Please find attached our INFINEON Technologies PCN:

Additional assembly site for TO-220 products - Revised D2Pak removed

Date: Friday, April 15, 2016
PCR Reference: 220
PCN Reference: 220-PCN90-Public

TO220-AB POD COMPARISON

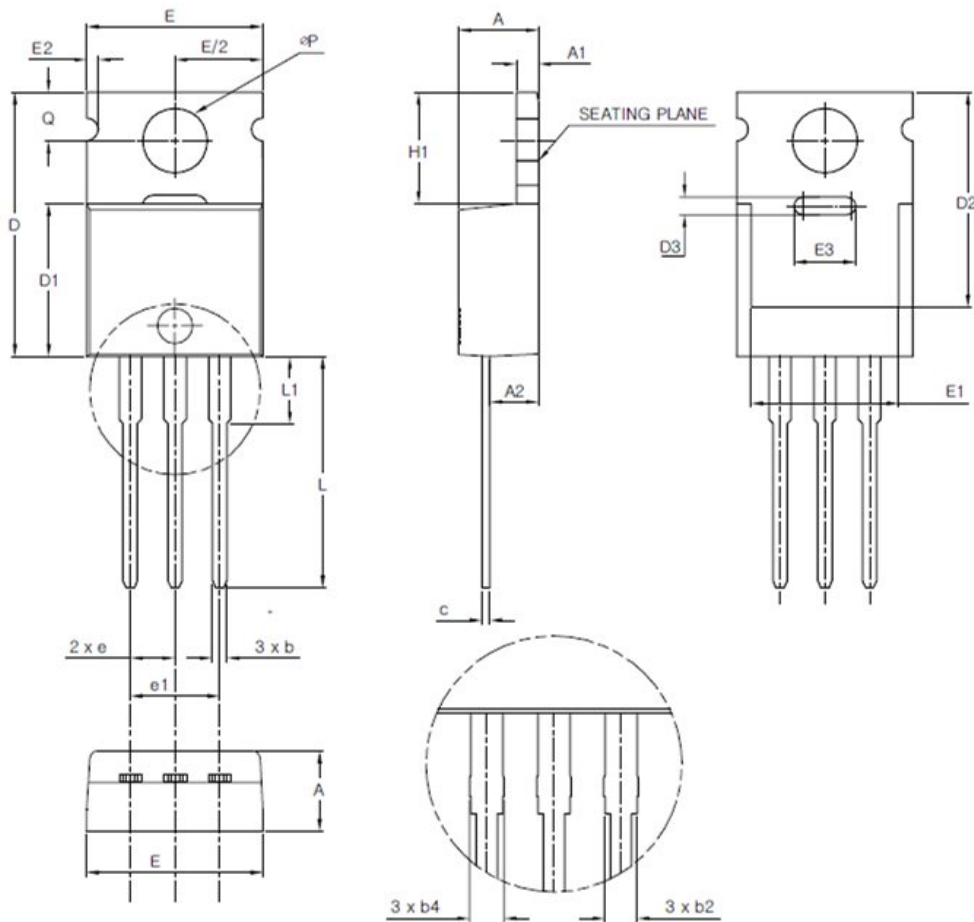
Additional assembly site for TO-220 products - **Revised D2Pak removed** Super Power Semiconductors (Korea) will be the alternate assembly site for the part numbers identified in the following page. As a result of this change, the package will change as follows

PACKAGE	ITEM	EXISTING	TARGET
TO-220	Assembly site	International Rectifier Mexico	Super Power Semiconductors (SP Korea)
	Mold compound	43-9807	44-1197
	Wire	Ni-doped Aluminum	Aluminum
	Die attach solder	Sn/Ag/Sb	Pb/Sn/Ag
	Leadframe	Selective Ni	Bare Copper
	Lead plating	Sn/0.7Cu Solder Dip	100 Matte Sn

Package Outline Comparison TO-220

Reference	IR POD		SP POD		JEDEC POD	
	Min	Max	Min	Max	Min	Max
A	3.56	4.83	3.56	4.83	3.56	4.83
A1	0.51	1.40	0.51	1.40	0.51	1.40
A2	2.03	2.92	2.03	2.92	2.03	2.92
b	0.38	1.01	0.38	1.01	0.38	1.01
b2	1.14	1.78	1.14	1.78	1.14	1.78
c	0.36	0.61	0.36	0.61	0.36	0.61
D	14.22	16.51	14.22	16.51	14.22	16.51
D1	8.38	9.02	8.38	9.02	8.38	9.02
D2	11.68	12.88	11.68	12.88	12.19	12.88
E	9.65	10.67	9.65	10.67	9.65	10.67
E1	6.86	8.89	6.86	8.89	6.86	8.89
e	100 BSC		100 BSC		100 BSC	
H1	5.84	6.86	5.84	6.86	5.84	6.86
L	12.70	14.73	12.70	14.73	12.70	14.73
L1	3.56	4.06	3.56	4.06	3.56	4.06
ØP	3.54	4.08	3.54	4.08	3.54	4.08
Q	2.54	3.42	2.54	3.42	2.54	3.42
